WINNTEC Model #6020 LP REGULATOR

Bulletin Type:	RCL	Publication Date:	November 2021
Bulletin #(s):	21V-685 US 2021-562 Canadian	Make(s):	Jayco
Job Code(s):	9901570A - Inspection Only 9901570B - Inspection, Complete Replace, LP Leak Test	Model(s):	Various Models
Flat Rate(s):	9901570A - .10 hr 9901570B - .70 hr	Model Year(s):	2017-2022

WINNTEC Model #6020 LP REGULATOR

INSPECTION OF WINNTEC MODEL #6020 LP REGULATOR

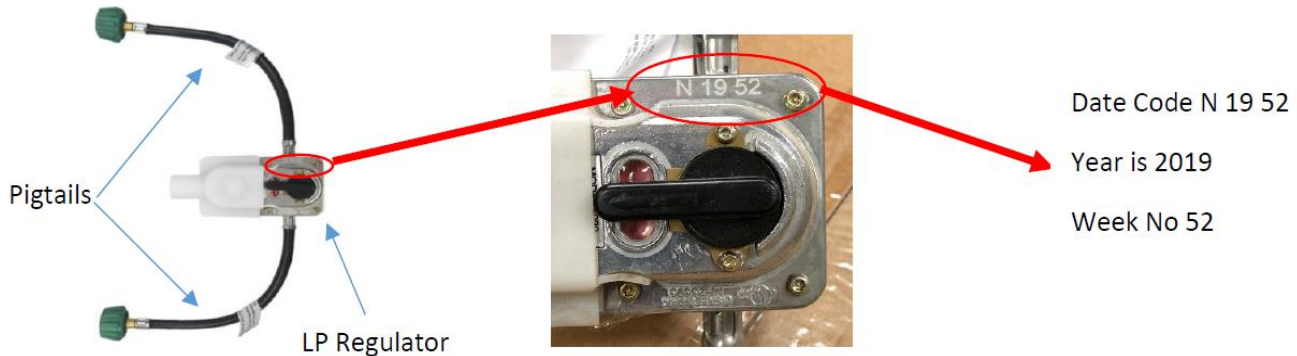
1. Only the Winntec Model #6020 - Dual Stage Double Cylinder - Automatic Changeover Regulator with Pigtails is affected. Replace the regulator and pigtails if the manufacturing date code stamped into the regulator is 2017, 2018, 2019 or 2020. Example shown below.

2. File a claim for inspection only if the unit does not have a Winntec model #6020 LP regulator or if the date code stamped into the regulator is not 2017, 2018, 2019 or 2020.
